# Town of Franklin

## Planning Board

July 13, 2020

Re: Request for Final Certificate of Completion  
300 Financial Park – Warehouse Development (the Project)  
431 Washington Street, Franklin, MA

SHEET 5 OF 12

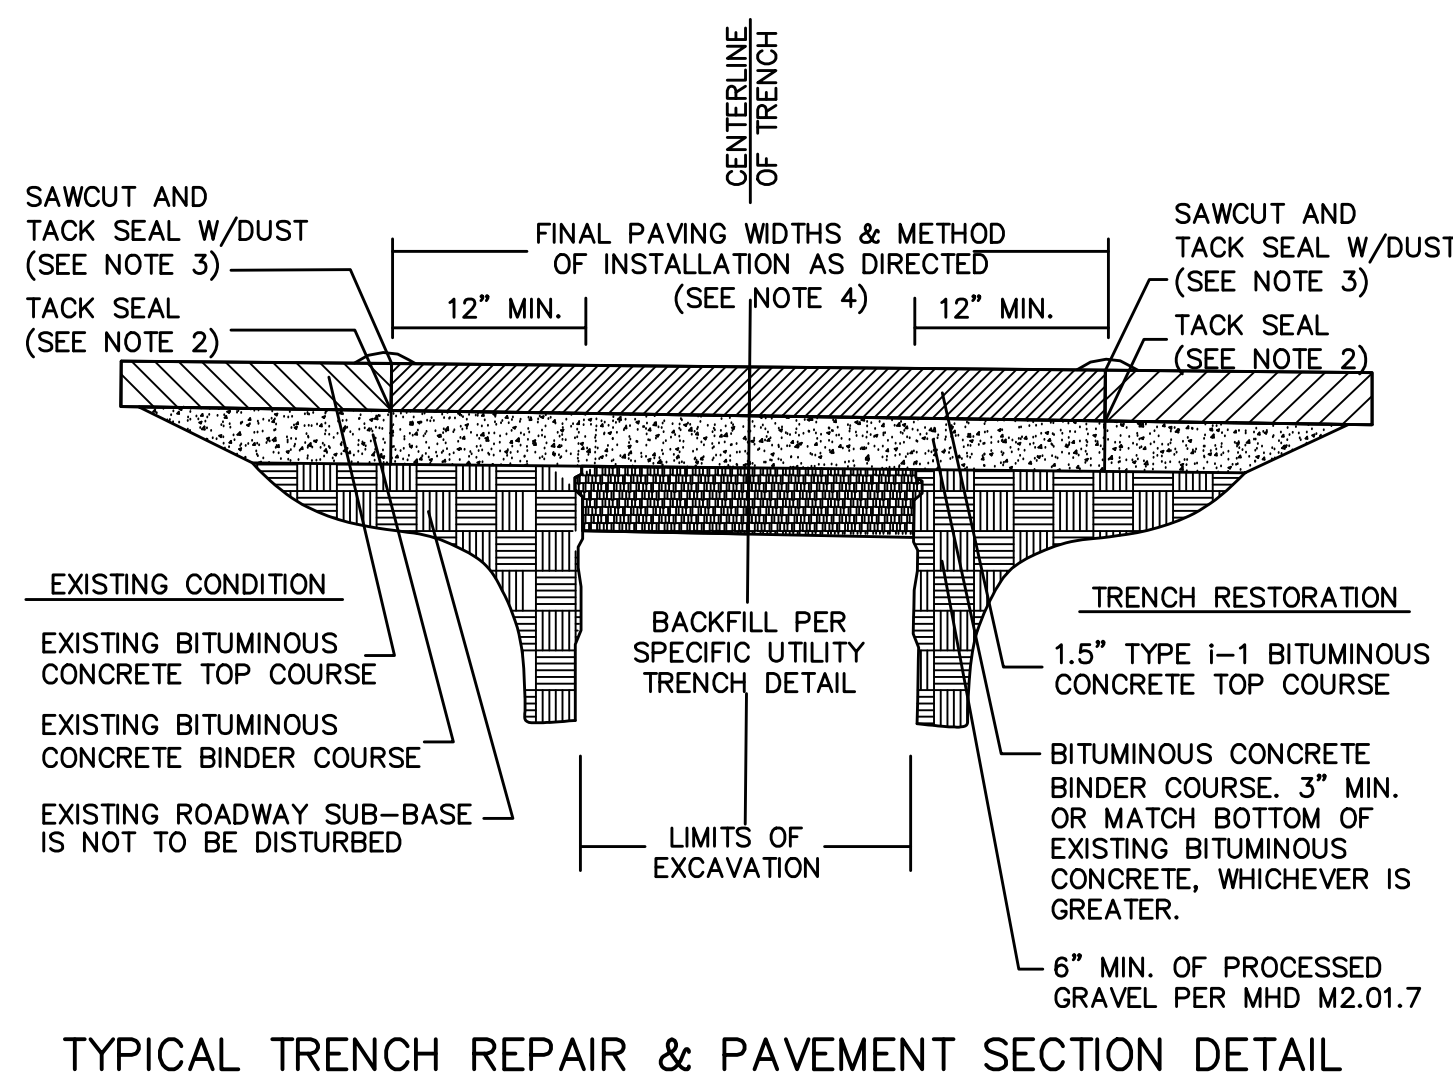
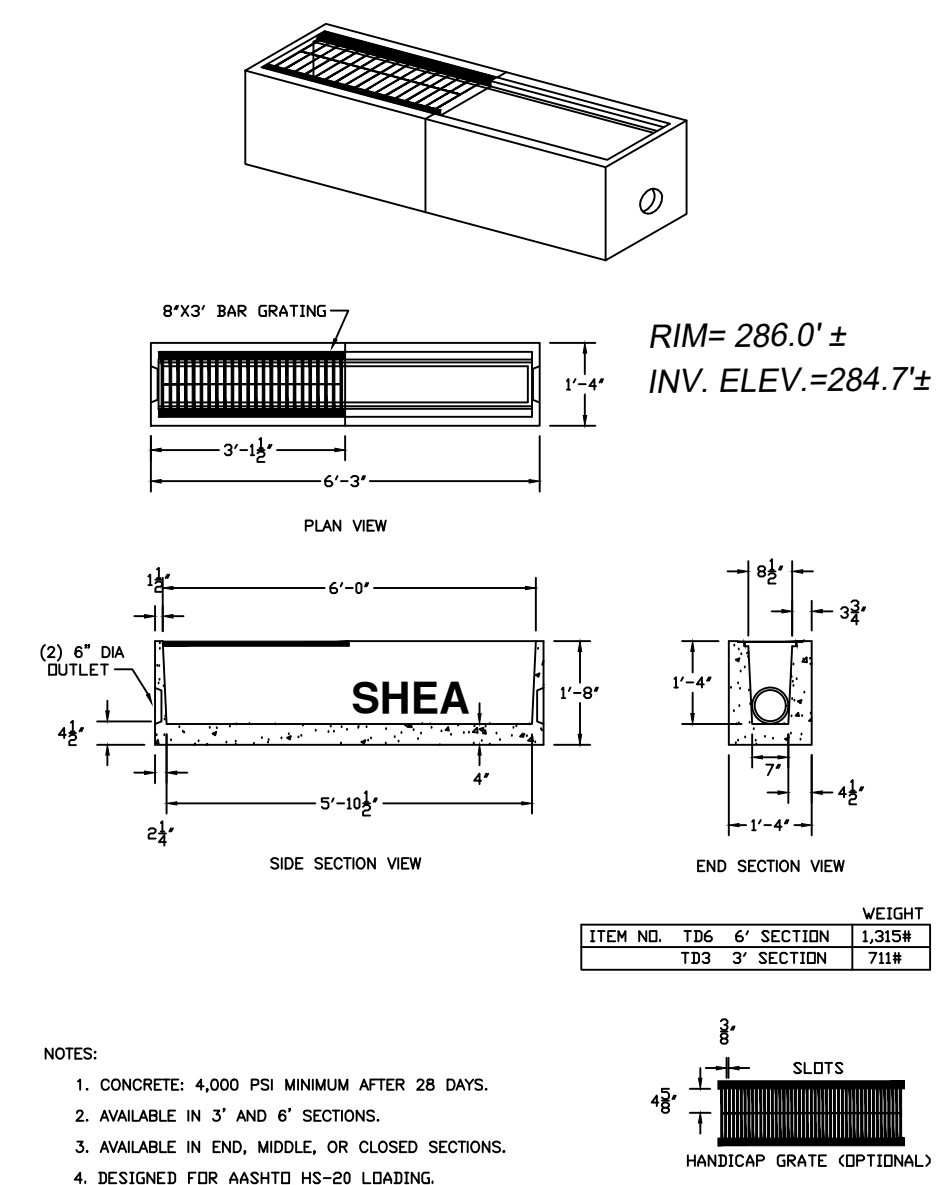
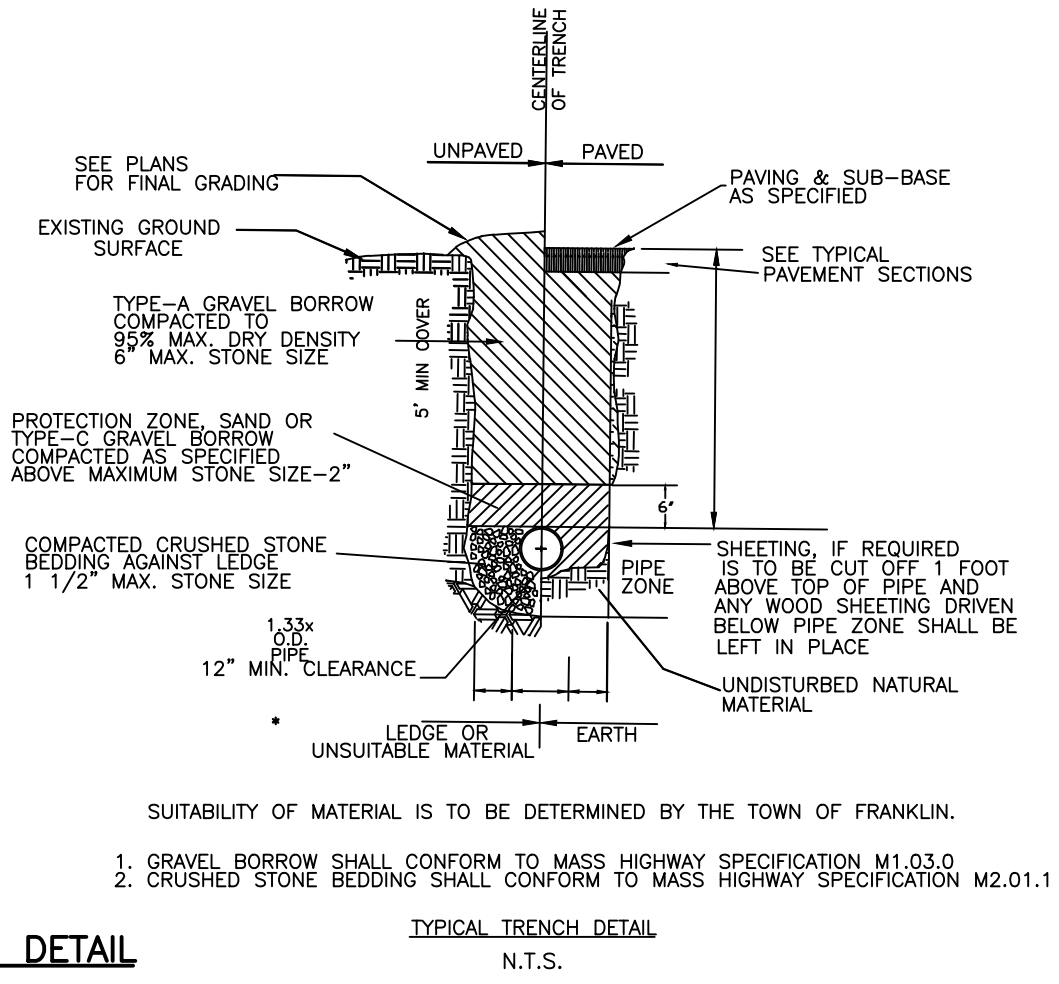
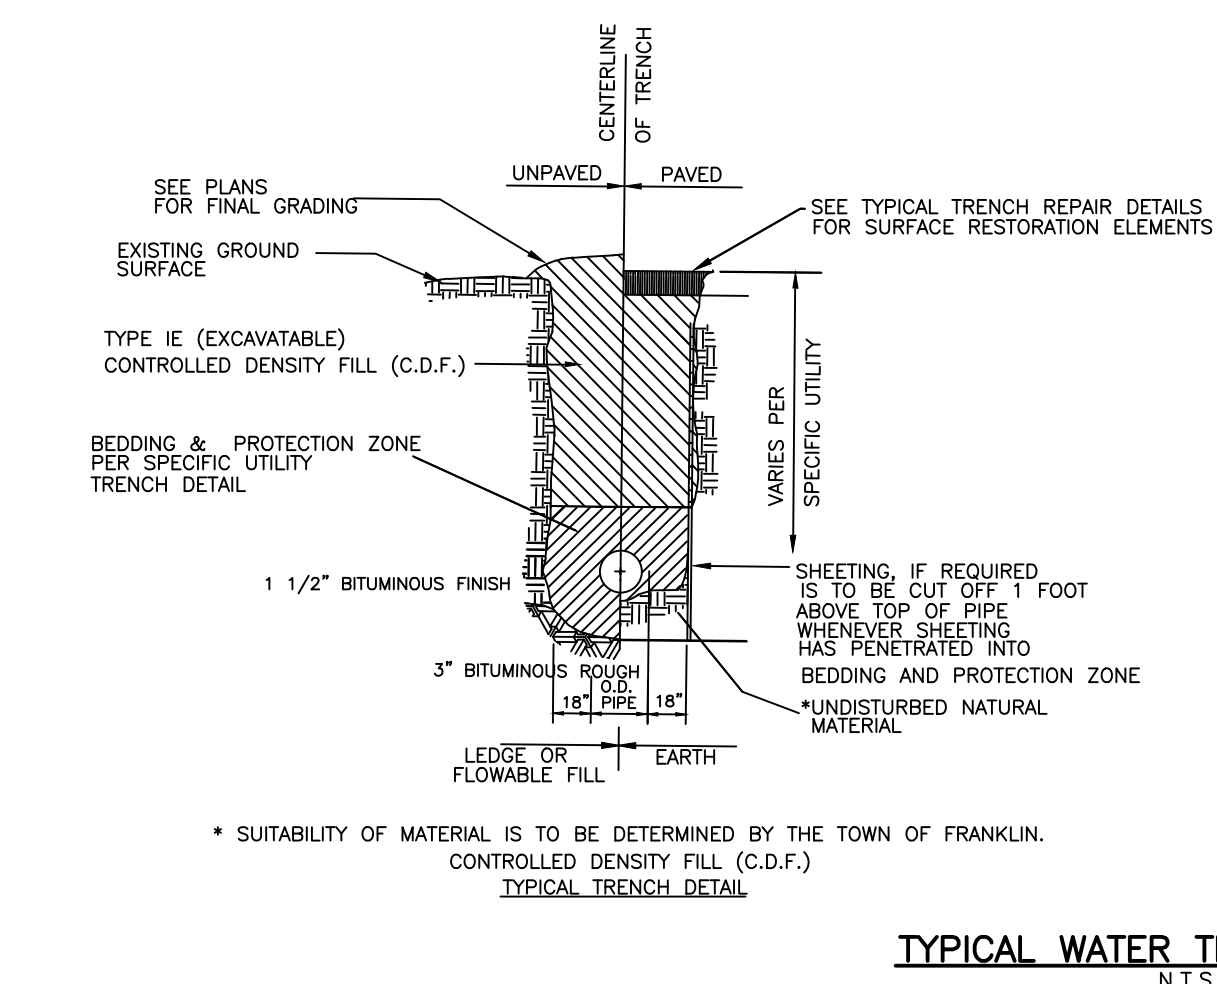
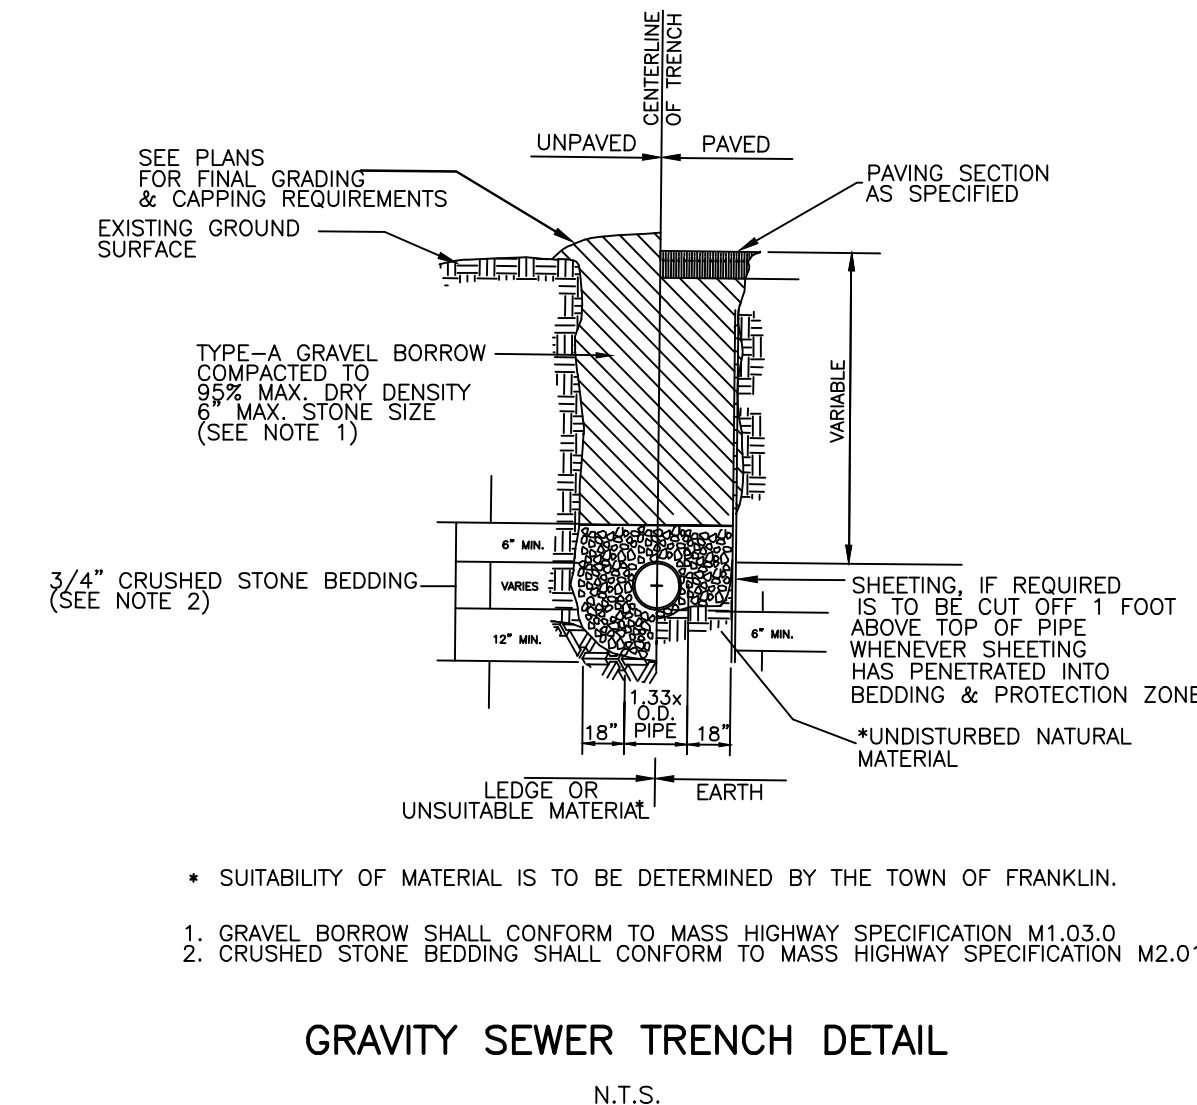
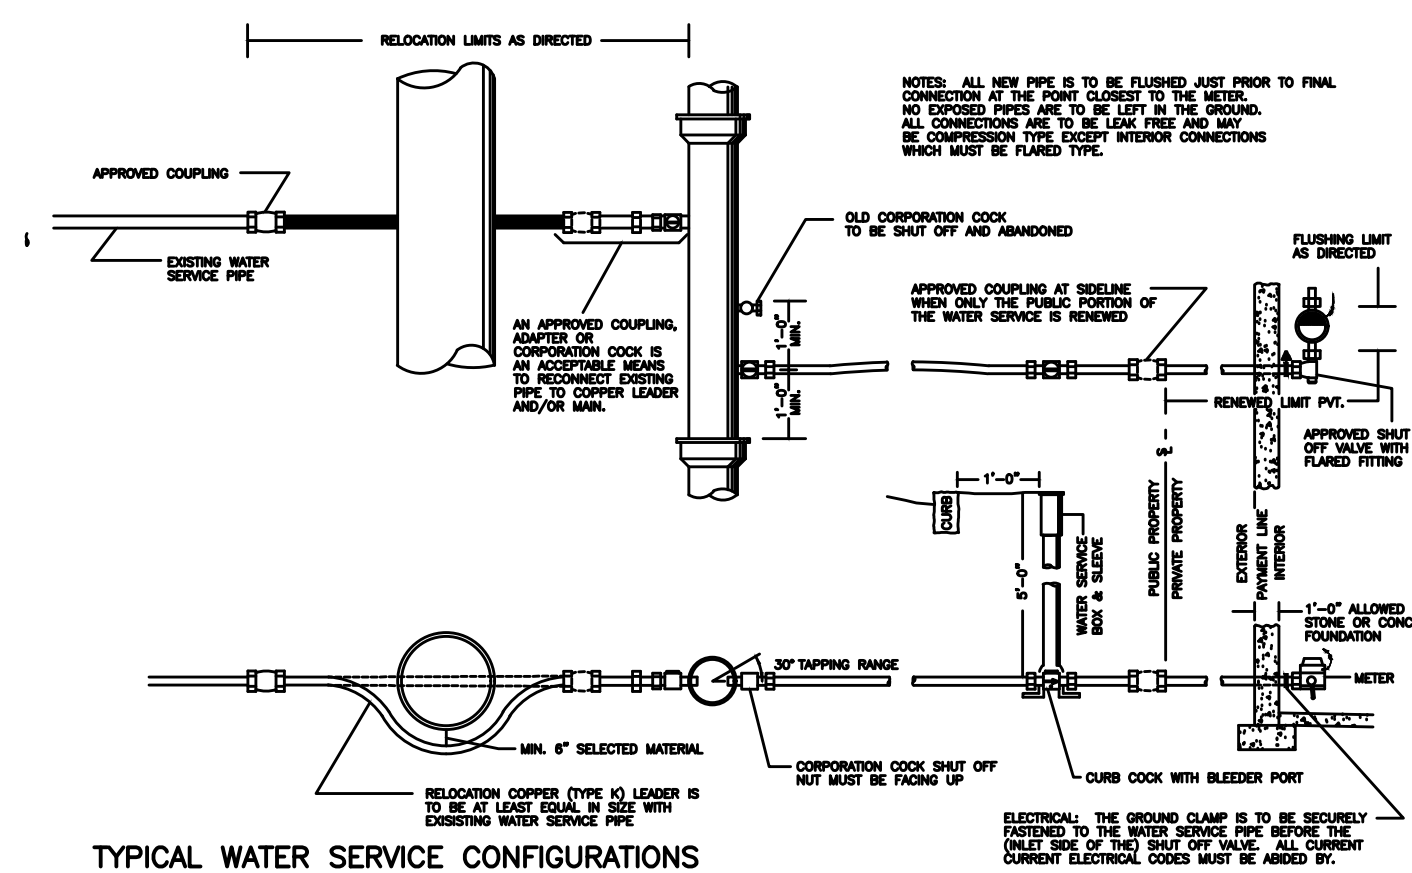
SW22. The Best Development Practices Guidebook does not permit the use of haybales or silt fence. Revise perimeter controls to use straw wattles or compost filter tubes. SE: Spruhan Engineering added erosion control plan showing straw wattles. *BETA2: Remove silt fence from Details (Sheet 4 of 9).*

- G2. Provide details for pavement, sidewalks, walkways, driveway, wheelchair ramps, dumpster pad and screened enclosure, signs, sewer structure, plantings, and other site features. *SE: Spruhan Engineering added details.* **BETA2: Majority of details not provided – issue remains outstanding.** *SE2: Missing details has been added to the plan, please see Sheet #4 to Sheet #7 and attached Landscape Plan.* **BETA3: Requested details provided except for dumpster pad and enclosure; however, a note has been added to the plans indicating dumpster to be placed on concrete pad and surrounded by chain link fence. Typically, the Board requires chain link fence for dumpsters to include vinyl slats for screening.**

**SE: Missing details has been added to the plan, please see Sheet#4 to Sheet#7 and attached Landscape plan.**

**SE: Detail has been removed, please see Sheet#4.**
